Project Name
120 Archway

Drawing Title
Proposed GA & Setting Out Plan -
Ground Floor

Scale	Drawn by
As indicated@ A1	Author
Date	Checked by
16.03.26	Checker
Drawing Number	Revision
24040 - GA - 100	A

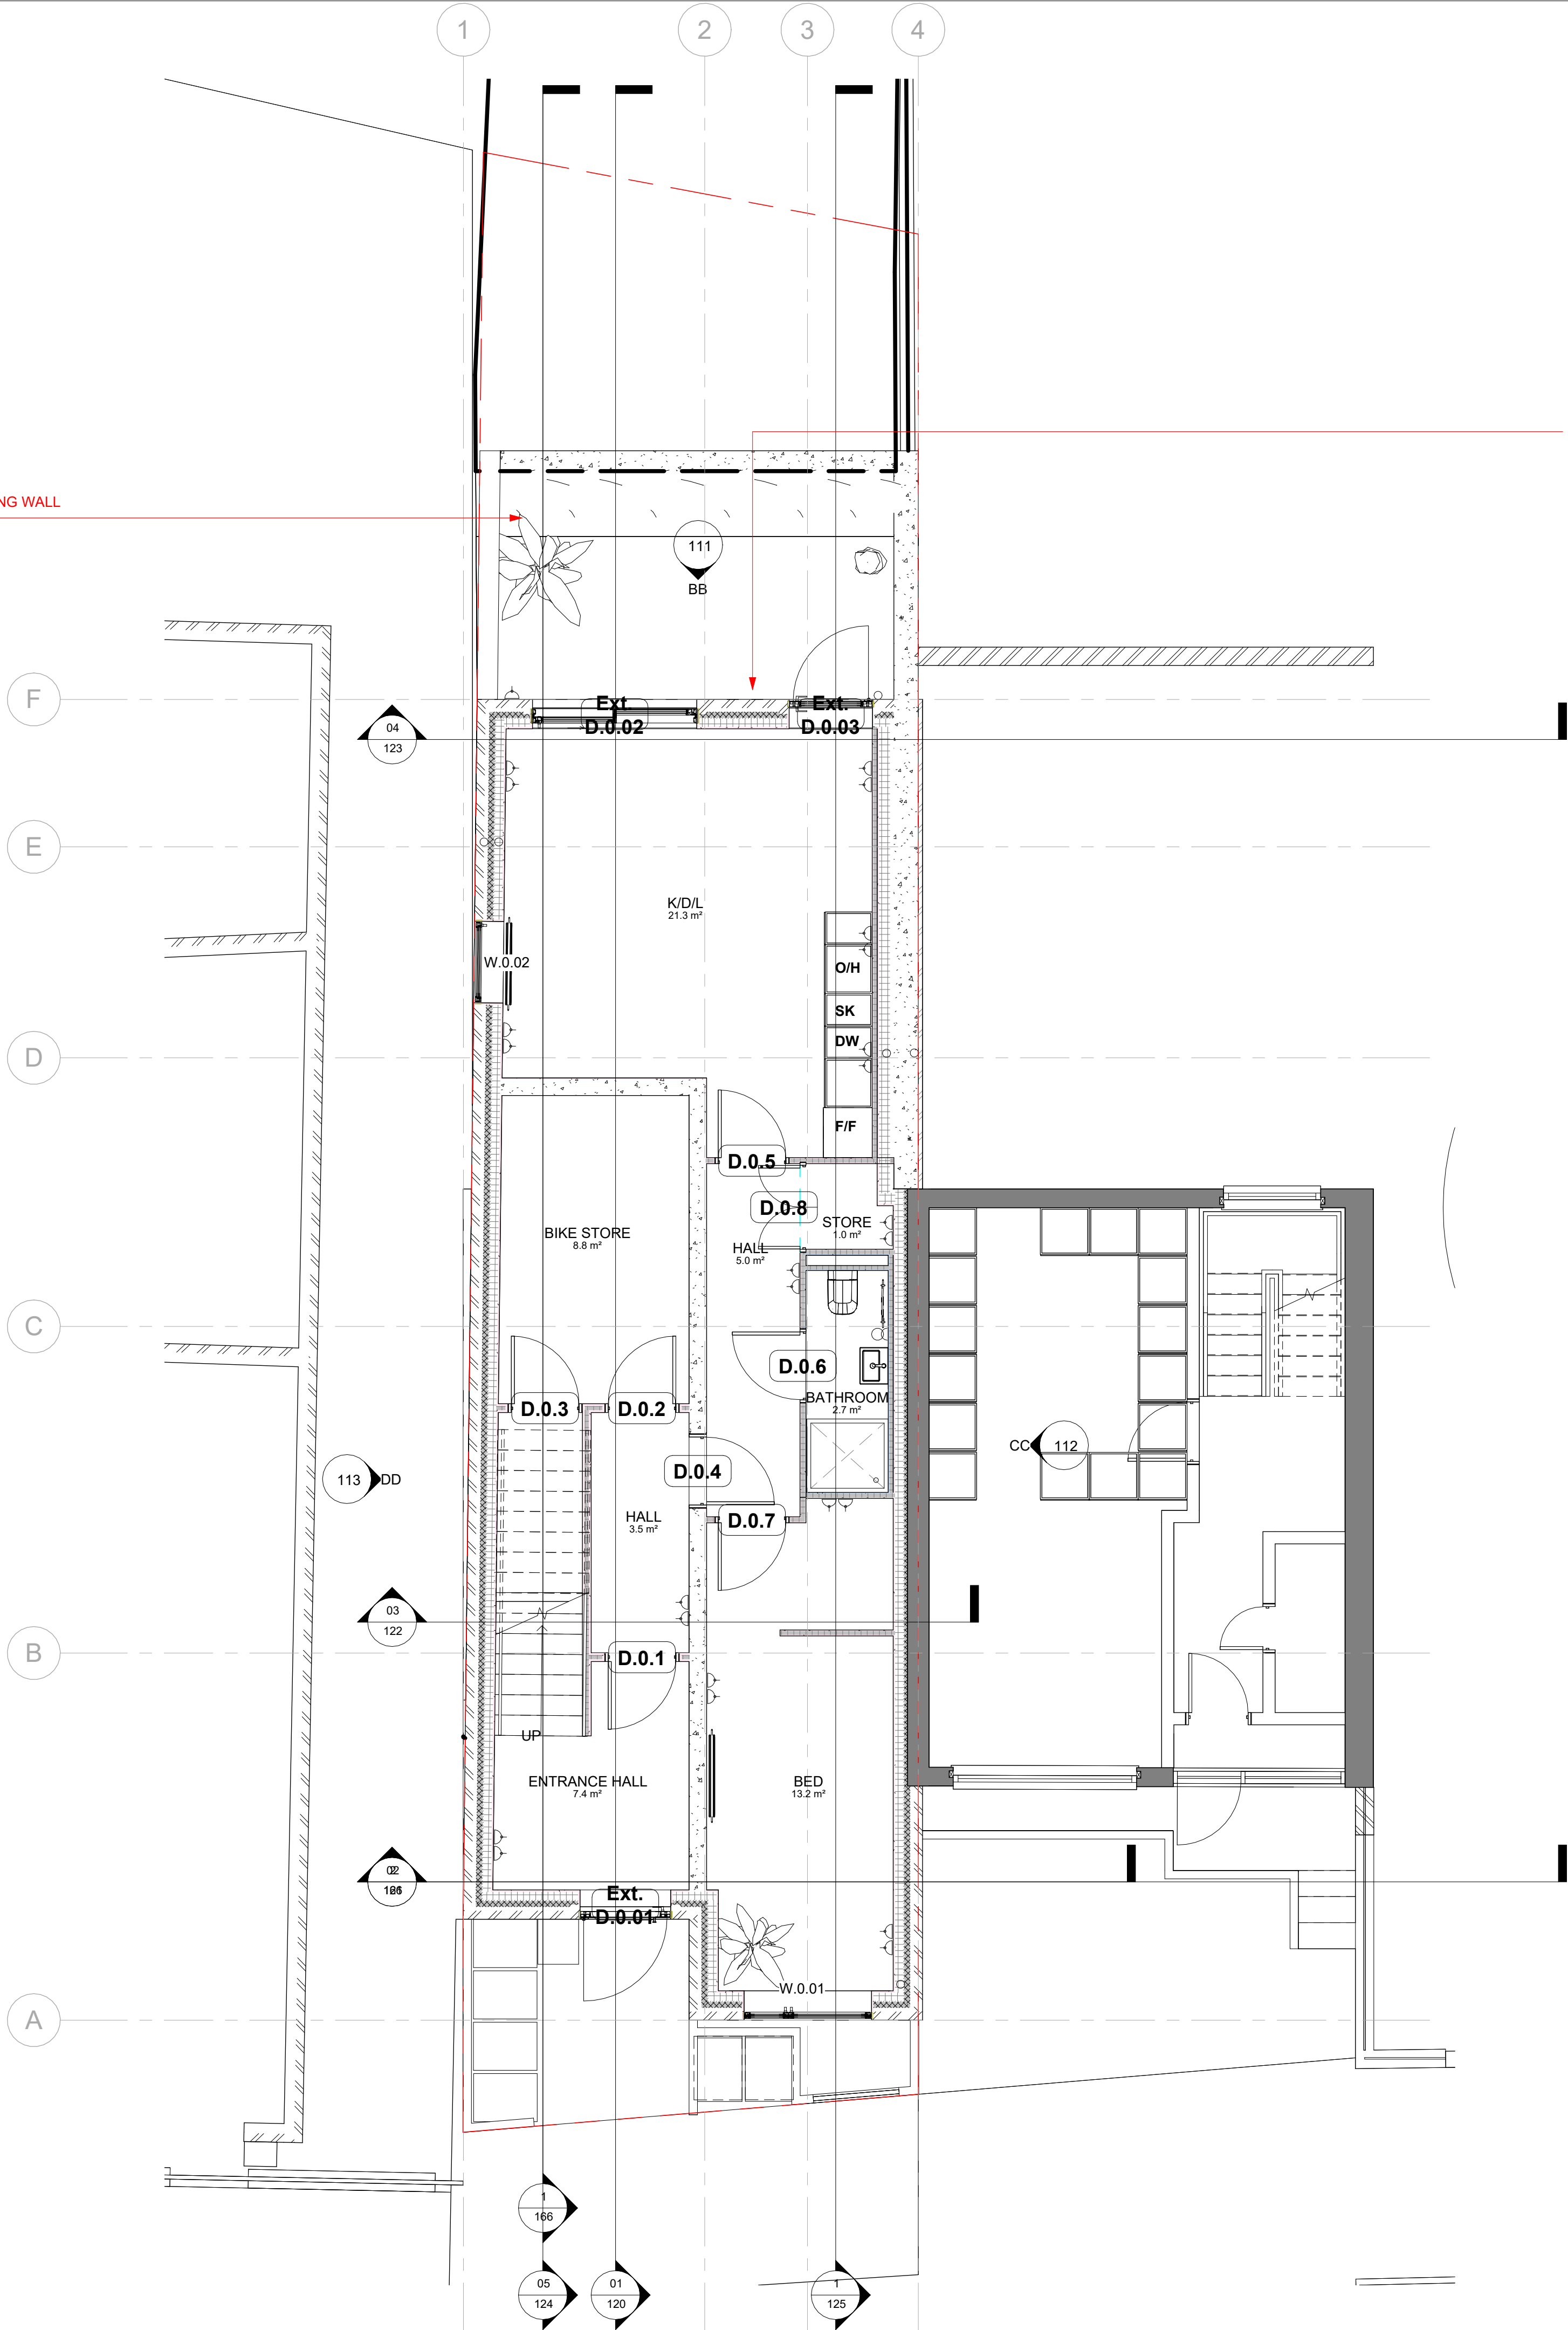
BRICK DIMS TO BE ADJUSTED
ONCE PARTY WALL AGREEMENT
IS IN PLACE

INTRODUCTION OF PILLAR BETWEEN
GLAZING

16.03.26 UPDATED REAR RETAINING WALL
SETTING OUT PROPOSAL.
